SAN ANTONIO WATER SYSTEM
University Pump Station Improvements Project
SAWS Job No. 12-6002
Solicitation No. B-14-002-DD

ADDENDUM NO. 9
April 23, 2014

SAWS JOB NO. 12-6002
UNIVERSITY PUMP STATION
IMPROVEMENTS PROJECT
ELECTRICAL DUCTBANK SECTIONS AND
SCHEDULES - 1

SAWS JOB NO. 12-6002
UNIVERSITY PUMP STATION
IMPROVEMENTS PROJECT
ELECTRICAL
DUCTBANK SECTIONS AND
SCHEDULES - III

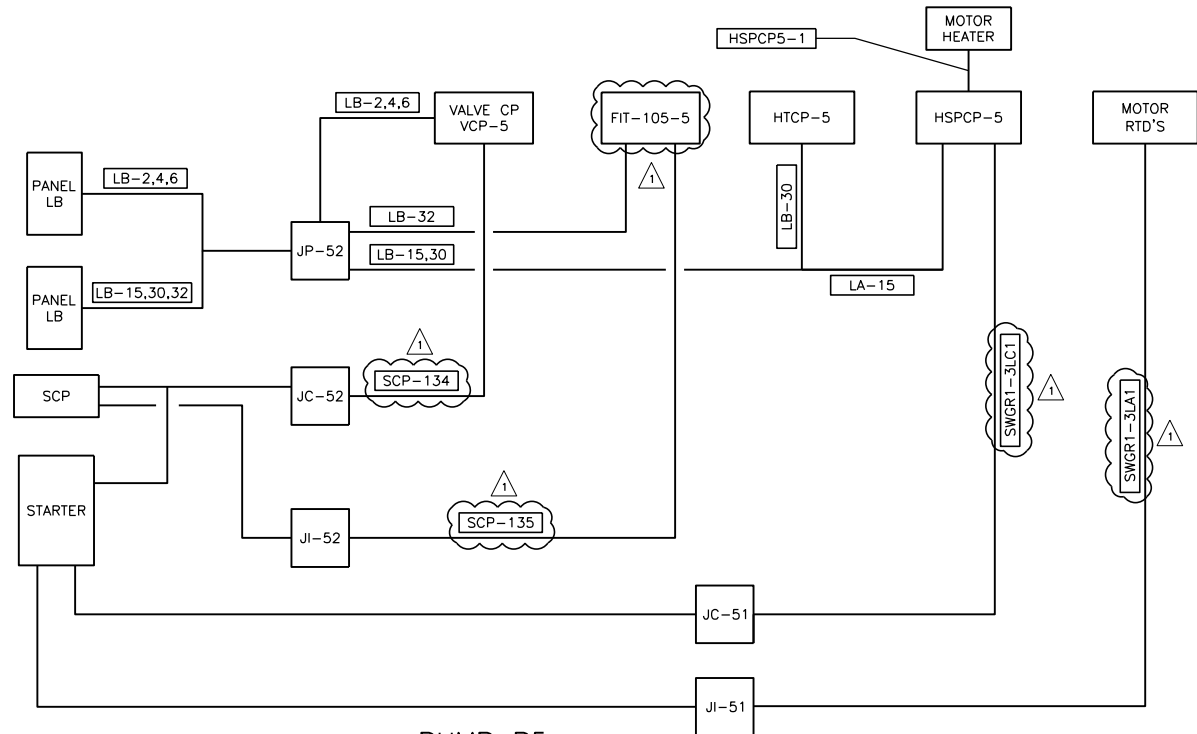
39. **Question:** On sheet E-07A (Ductbank Section 47), there are 4 conduits that I think might not belong in this section. There are conduit #'s 4-7 and are also in Ductbank Section 6, involving the Altitude Vault on the other side of the site. Ductbank 47 goes to EHH-3 and the conduits are to continue to feed the High Service Pumps in that area. Please clarify.

Answer: Yes, the conduits are associated with HSP-1, HSP-2 and HSP-3. See Addendum #9, Part 2, Item #6.

SAWS JOB NO. 12-6002
 UNIVERSITY PUMP STATION
 IMPROVEMENTS PROJECT
 ELECTRICAL
 RISER DIAGRAM

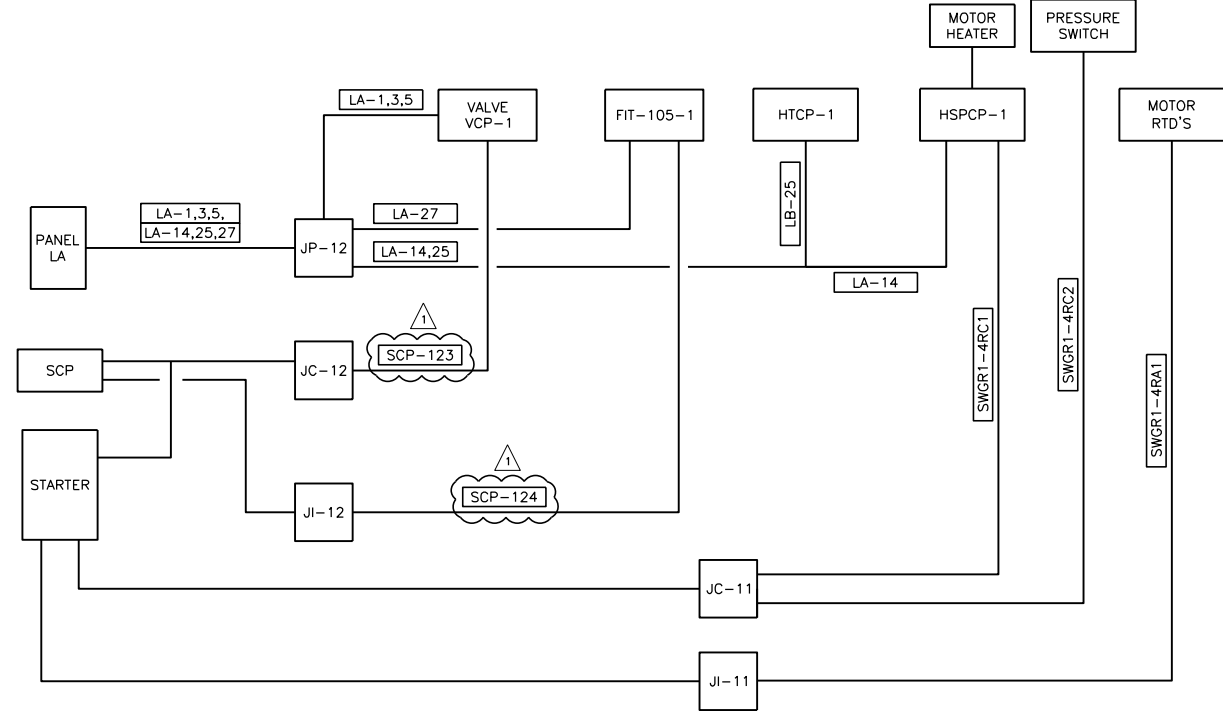
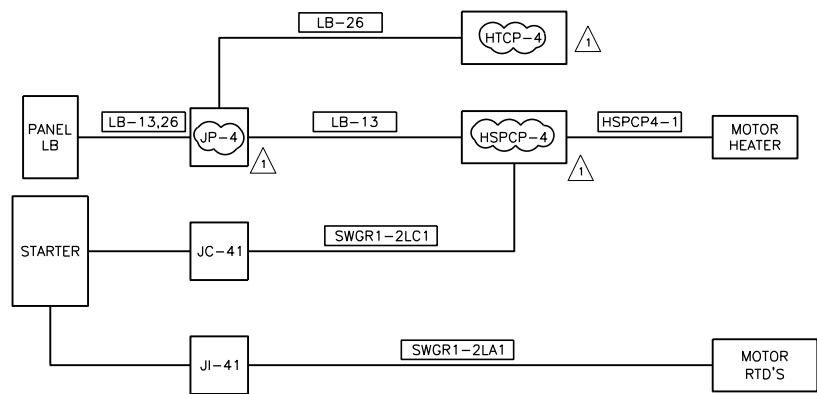
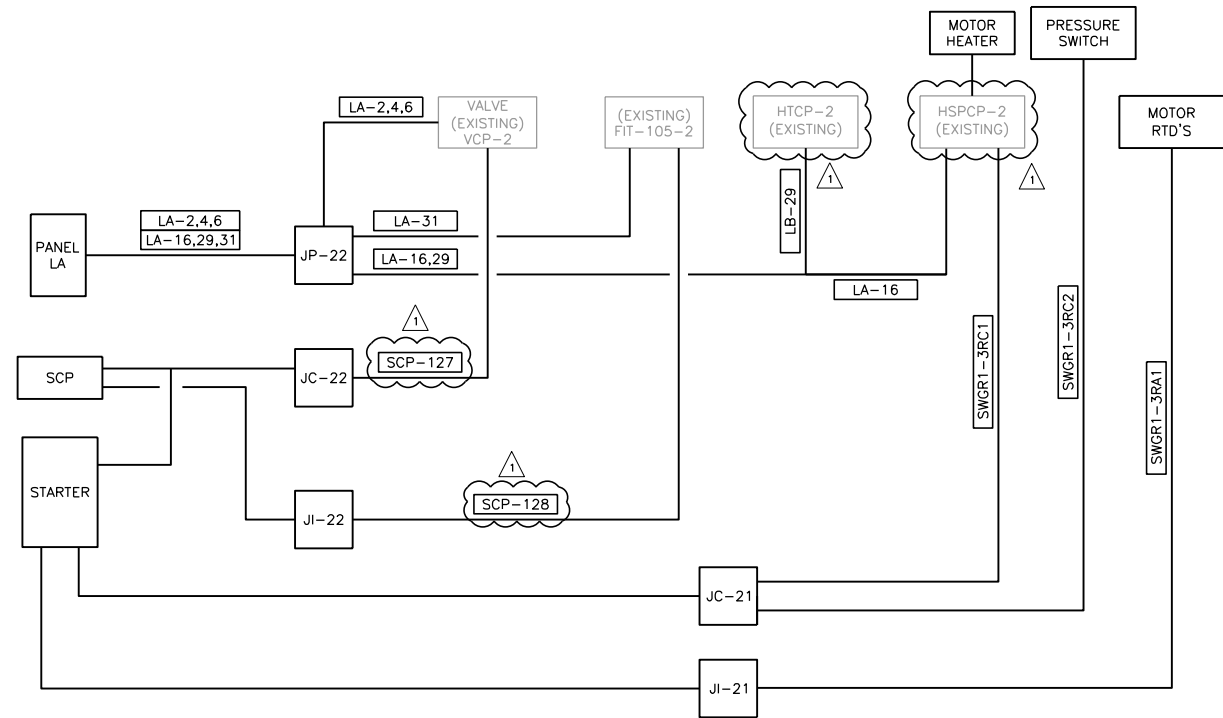
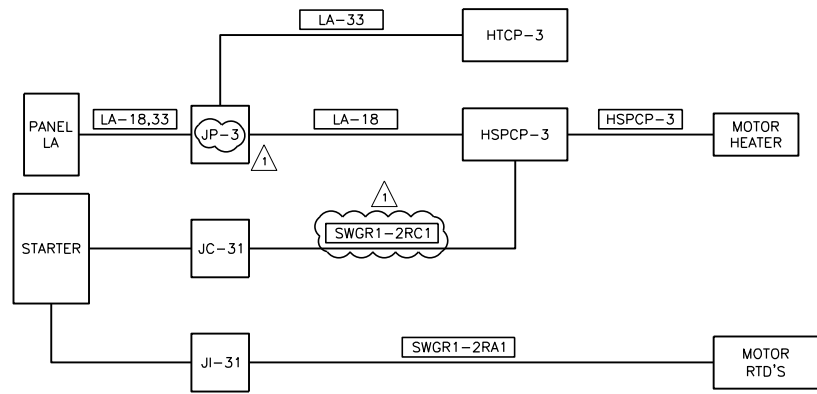
8. **Question:** On sheet E-24, the SCP wire number identification doesn't relate to the SCP wire numbers per sheet E-20 per Addendum #2. Please clarify.

12. **Question:** On sheet E-24 (Pump P5 Riser Diagram), the conduit from [JC-51] to [HSPCP-5] is tagged [SWGR1-3RC1]. On sheet E-09, the same conduit is tagged [SWGR1-3LC1]. Please clarify.

13. **Question:** On sheet E-24(Pump P5 Riser Diagram), the conduit from [JI-51 } to [Motor RTD’s] is tagged [SWGR1-3RA1]. On sheet E-09 the same conduit is tagged [SWGR1-3LA1]. Please clarify.

14. **Question:** On sheet E-24 (Pump P4 Riser Diagram), the conduit from [JC-52] to the existing flow meter is tagged [SCP-132] and the existing flow meter is tagged [FIT-105-3]. On sheet E-20, the conduit is tagged [SCP-135] and the flow meter is tagged [FIT-105-5]. Please clarify.

15. **Question:** On sheet E-24 (Pump P4 Riser Diagram), the Heat Trace Control Panel and the High Service Pump Control Panel are labeled [HTCP-3] and [HSPCP-3]. On sheet E-14, the same control panels are labeled [HTCP-4] and [HSPCP-4]. Please clarify.

16. **Question:** On sheet E-24 (Pump 4 Riser Diagram), conduit [LB-13, 26] terminates in J-box [JP-41]. On sheet E-14, this J-box is labeled [JP-4]. Also on sheet E-14, there is a box labeled [JP-41] that connects to ductbank #13. Which box is referenced on sheet E-24 in the Riser Diagram? Please clarify.

18. **Question:** On sheet E-24 (Pump P3 Riser Diagram), conduit [LA-18,33] terminates in J-box [JP-31]. On sheet E-14, this J-box is labeled [JP-3]. Also on sheet E-14, there is a J-box labeled [JP31] that connects to ductbank #15. Which J-box is referenced on sheet E-24 in the Riser Diagram? Please clarify.

19. **Question:** On sheet E-24 (Pump P3 Riser Diagram), the conduit from [JC-31] to [HSPCP-3] is tagged [SWGR1-2LC1]. On sheet E-10, the same conduit is tagged [SWGR1-2RC1]. Please clarify.

20. **Question:** On sheet E-24 (Pump P2 Riser Diagram), the conduit from [JI-22] to [FIT-105-2] is tagged [SCP-125]. On sheet E-20 the same conduit is tagged [SCP-128]. Please clarify.

22. **Question:** On sheet E-24 (Pump P1 Riser Diagram), the conduit from [JI-12] to [FIT-105-1] is tagged [SCP-123]. On sheet E-20, the same conduit is tagged [SCP-124]. Please clarify.

23. **Question:** On sheet E-24 (Pump P1 Riser Diagram), the conduit from [JC-12] to [VCP-1] is tagged [SCP-122]. On sheet E-07 (Ductbank Section #19), the conduit tag is only [SCP-]. Is [SCP122] the correct tag for conduit #4 in this ductbank? Please clarify.

25. **Question:** On sheet E-24 (Pump P2 Riser Diagram), the Heat Trace Control Panel and the High Service Pump Control Panel are labeled [HTCP-3] and [HSPCP-3]. On sheet E-15, these same control panels are labeled [HTCP-2] and [HSPCP-2]. Please clarify.

Answer: The SCP wire identification on sheet E-24 will be revised and issued as Addendum # 9, to match the sheet E-20, which was revised in Addendum #2. See Addendum #9, Part 2, Item #15.

Answer: Yes, the conduit should be tagged as SWGR1-3LC1. See Addendum #9, Part 2, Item #15.

Answer: Yes, the conduit should be tagged as SWGR1-3LA1. See Addendum #9, Part 2, Item #15.

Answer: Yes, the conduit should be tagged as SCP-135. See Addendum #9, Part 2, Item #15.

Answer: Yes, the label should be tagged as HTCP-4 and HSPCP-4. See Addendum #9, Part 2, Item #15.

Answer: Yes, on sheet E-24 the JP- 41 should be JP-4. See Addendum #9, Part 2, Item #15.

Answer: The JC-31 should be JP-3. See Addendum #9, Part 2, Item #15.

Answer: Yes, the conduit should be tagged as SWGR1-3RC1. See Addendum #9, Part 2, Item #15.

Answer: Yes, the tag should be SCP-128. See Addendum #9, Part 2, Item #15.

Answer: Yes, the tag should be SCP-124. See Addendum #9, Part 2, Item #15.

Answer: On E-24 and E-07 the conduit tag should be SCP-123. See Addendum #9, Part 2, Items #5 and #15.

Answer: Yes the panels should be HTCP-2 and HSPCP-2. See Addendum #9, Part 2, Item #15.
